# Access Compliance Report

## Public Rights-of-Way

### (Pedestrian Signals)

Intersection ID: N/A	Main Street:	Cross Street: N/A	Location: N/A
ADA ID: ED3B08B0D67A	Signal Type: One Push Button-Non APS	Overall Compliance: No	Severity Score: BTN 1: N/A BTN 2: N/A No BTN: N/A
Codes/Mitigation Info/Possible Solution		Field Measurements/Component Compliance

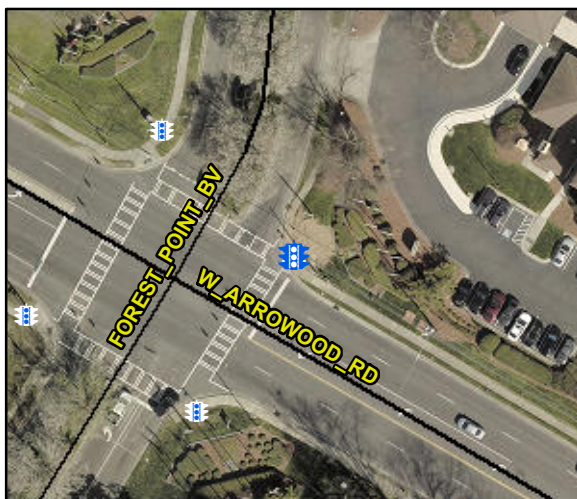
Possible Solutions: Provide Push Button Extension. Remove and Replace Clear Space.

PROW/ADA: R404.2, R406.2
